FILE P.I. # 222570-
EDS00-0441-00(044)
GDOT District 2 - Tennille
Morgan County
SR 24/US 441 From The Putnam CL to N of
CR 121/Pierce Dairy Road
Reconstruction/Rehabilitation

SUBJECT **APPROVED REVISED CONCEPT REPORT**

REVISED PROJECT CONCEPT REPORT

Project Number: EDS00-0441-00(44)
County: Morgan
P. I. Number: 222570
Federal Route Number: 441
State Route Number: 24

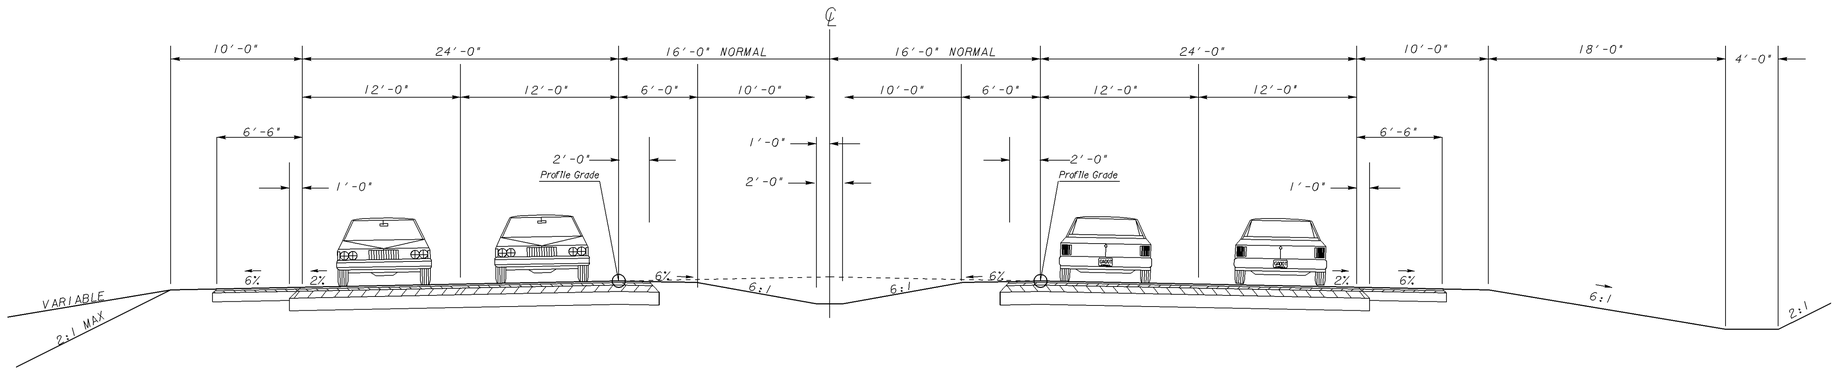
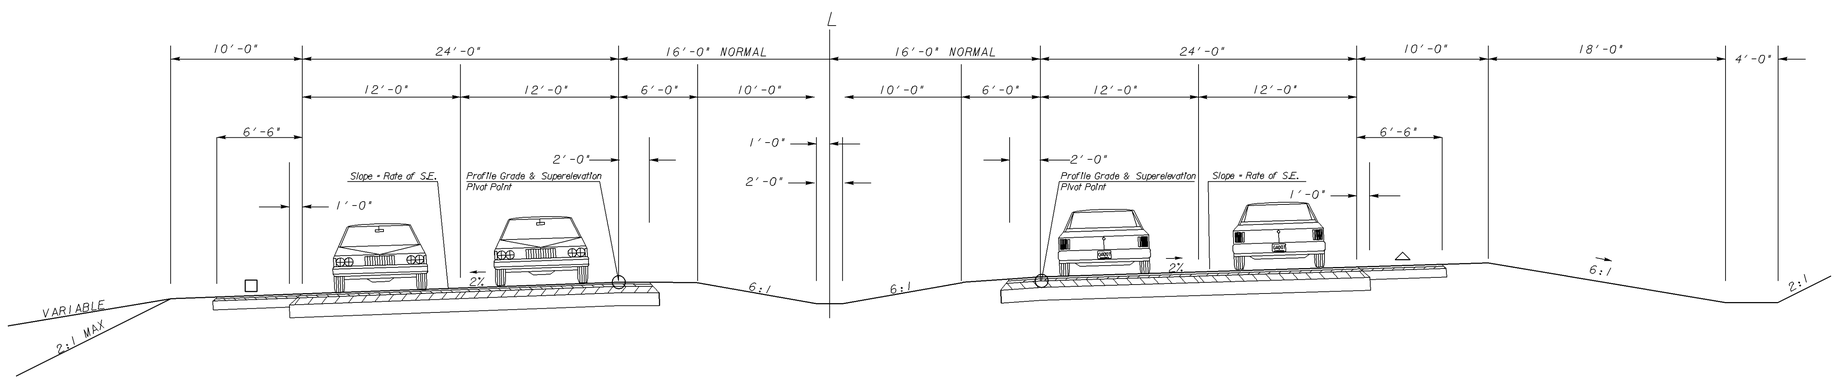
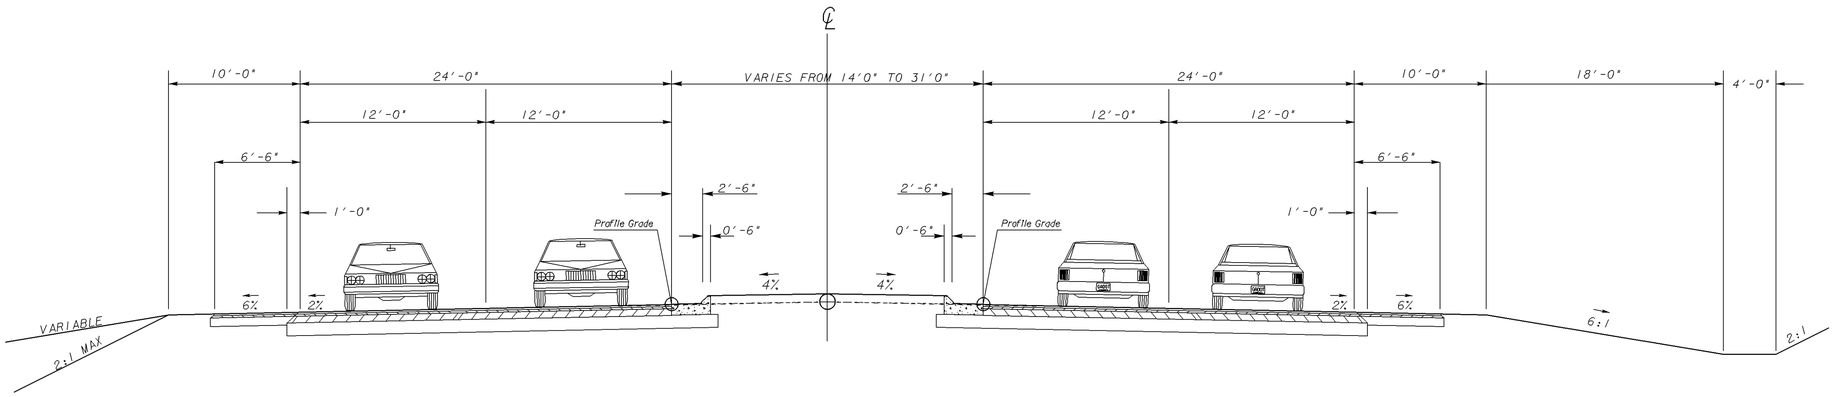
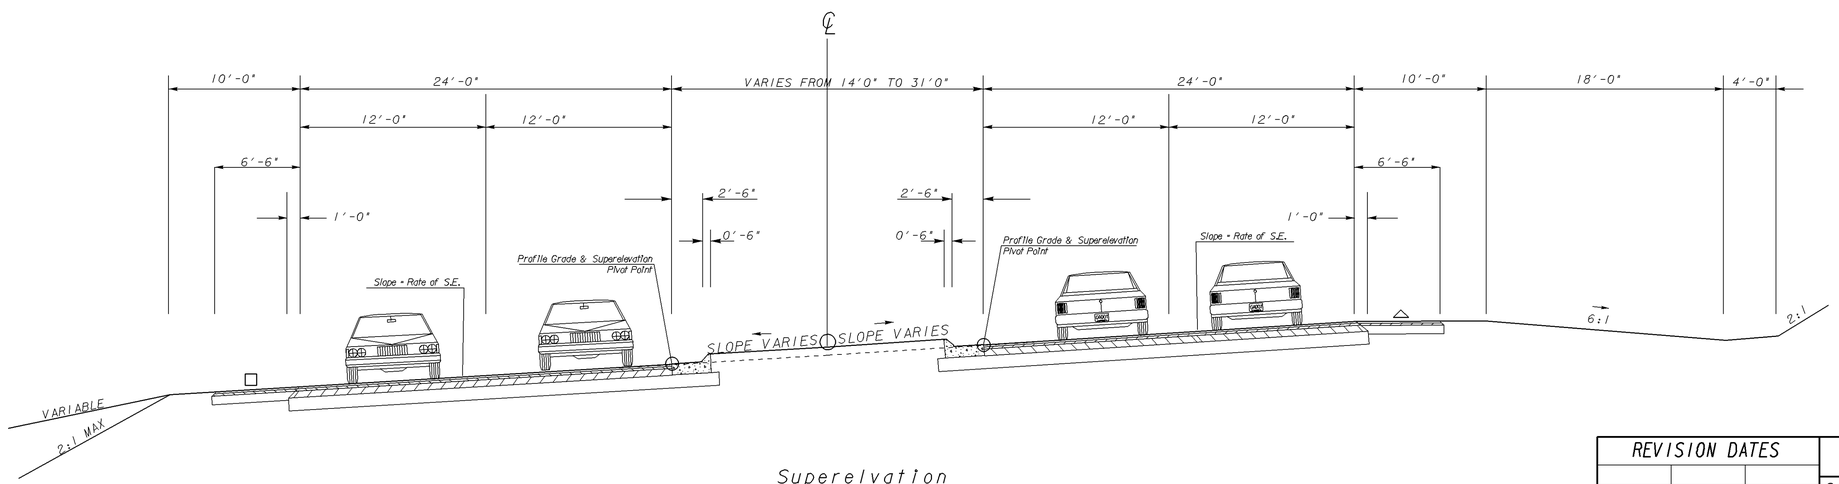
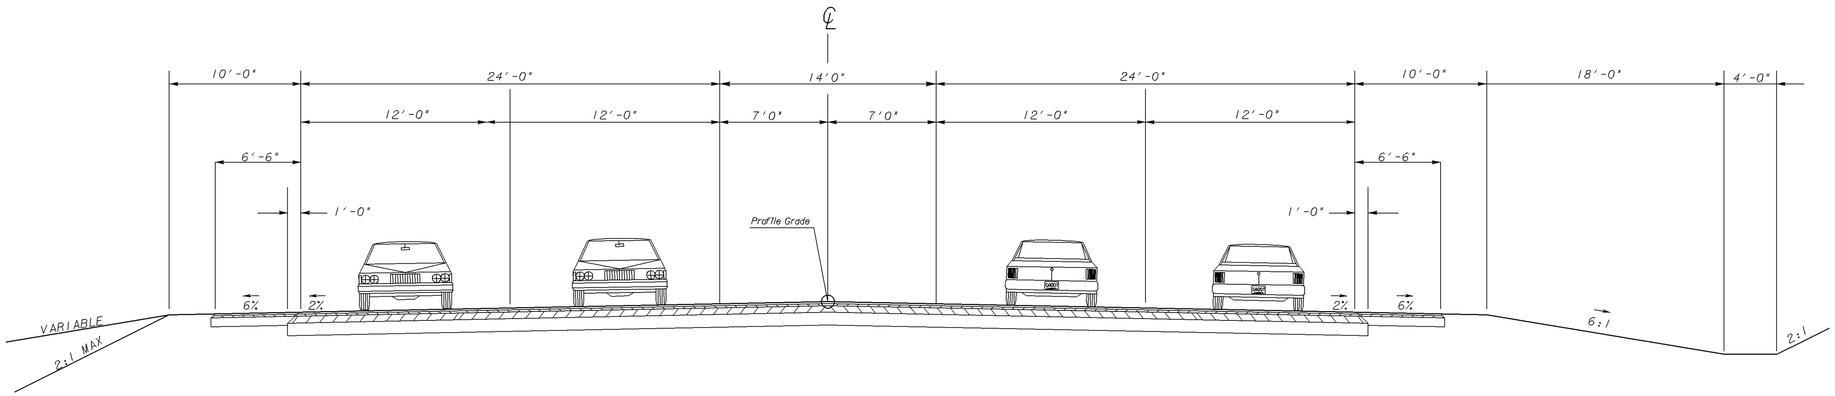
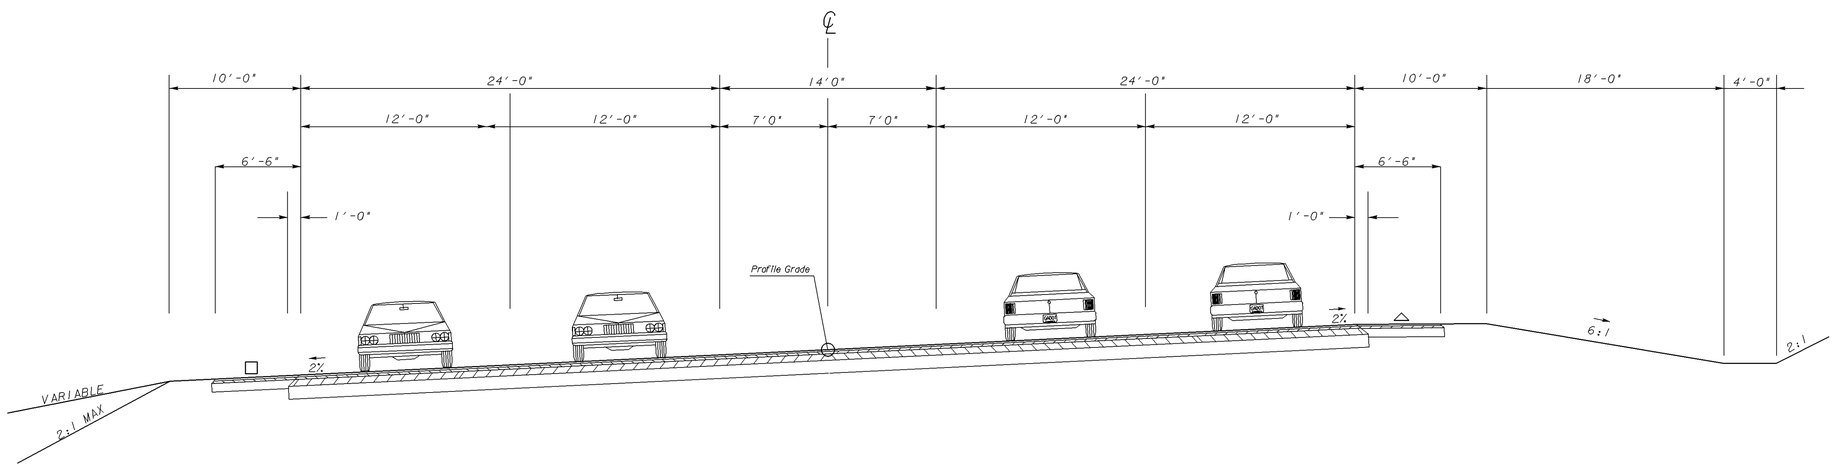
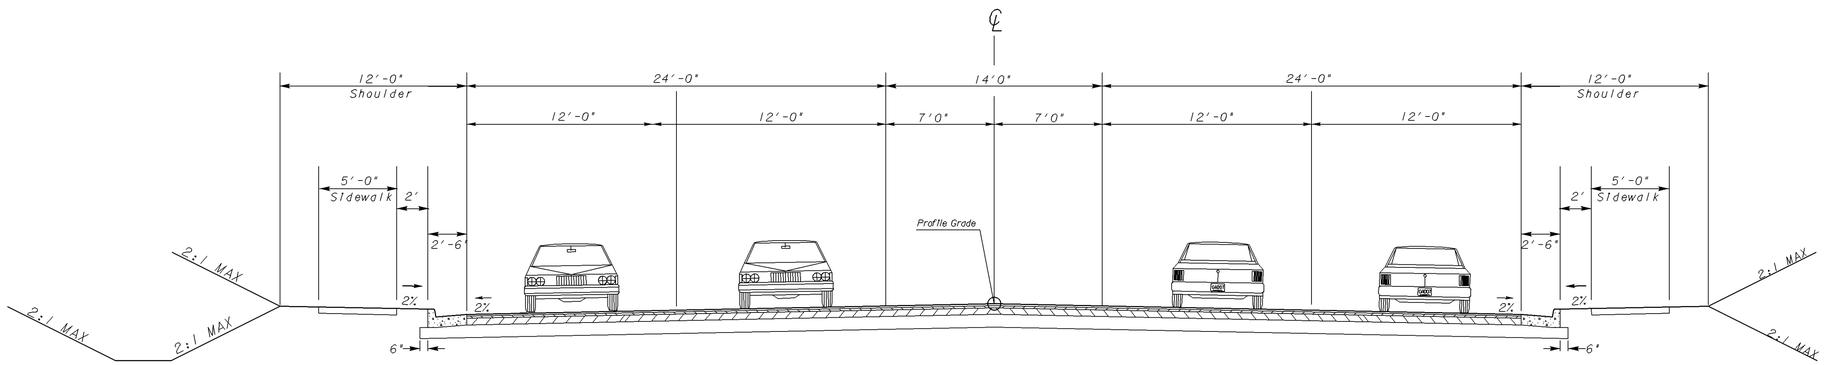
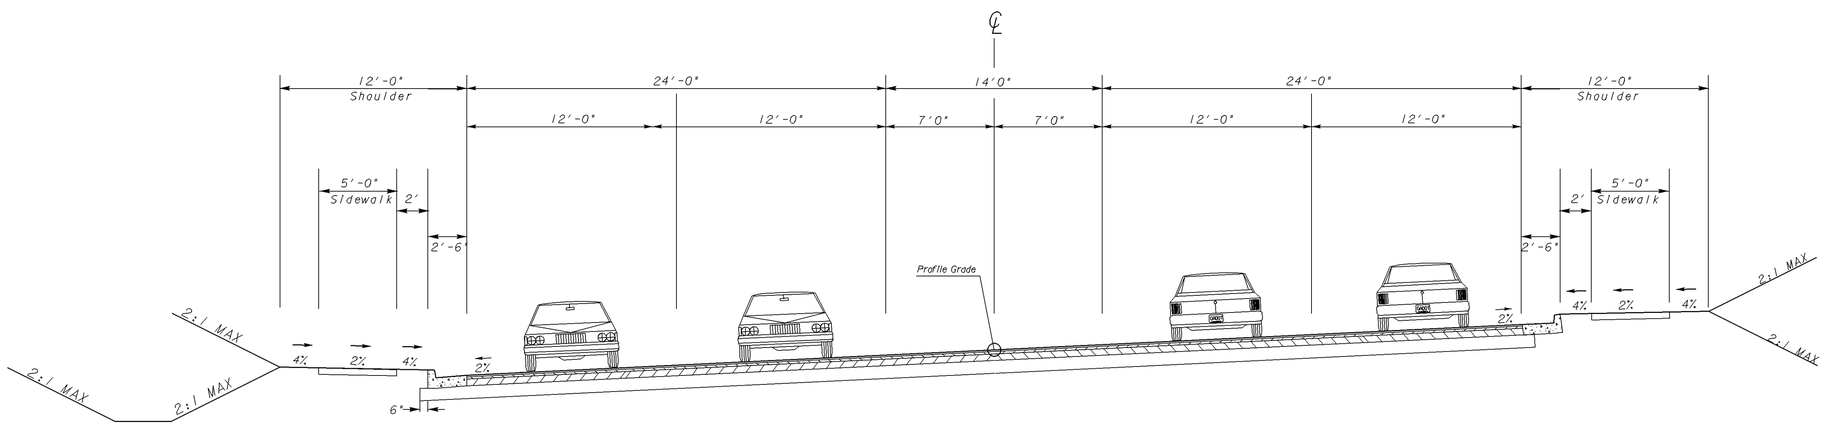
The median has been reduced from 44' to 32'

Approved Features: Typical Section	**Proposed Features:**
• This project proposes to widen the existing roadway from 2 and 3 lanes to 4 with a 44' grassed median and a 14' flush median.	The 44' grassed median will be revised to a 32' grassed median.
Reason for Change: The change is needed based on the VE Implementation letter dated April 17, 2008, to reduce the ROW impacts.

ALT No.	Description	Savings PW & LCC	Implement	Comments
EDS-441(45)				
ROADWAY (RD)				
RD-1	Reduce median width to 32' to reduce Right of Way	$512,862	Yes	This should be done.
RD-4	Re-align roadway to reduce required Right of Way	$93,688 (proposed) $31,226 (actual)	Yes	This will be done from Sta. 330+00 to Sta. 430+00 but will not be done from Sta. 700+00 to 750+00 due to Environmental impacts.
RD-5	Utilize Right of Way for Sediment Basins	Design Suggestion	No	Would result in Utility conflicts since the Sediment Basin would be located where proposed Utilities would be located.
RD-6	Utilize Right of Way to consolidate driveways	Design Suggestion	No	This would affect the property owner's ability to have a direct access to the mainline and could result in a negative impact to the property values.
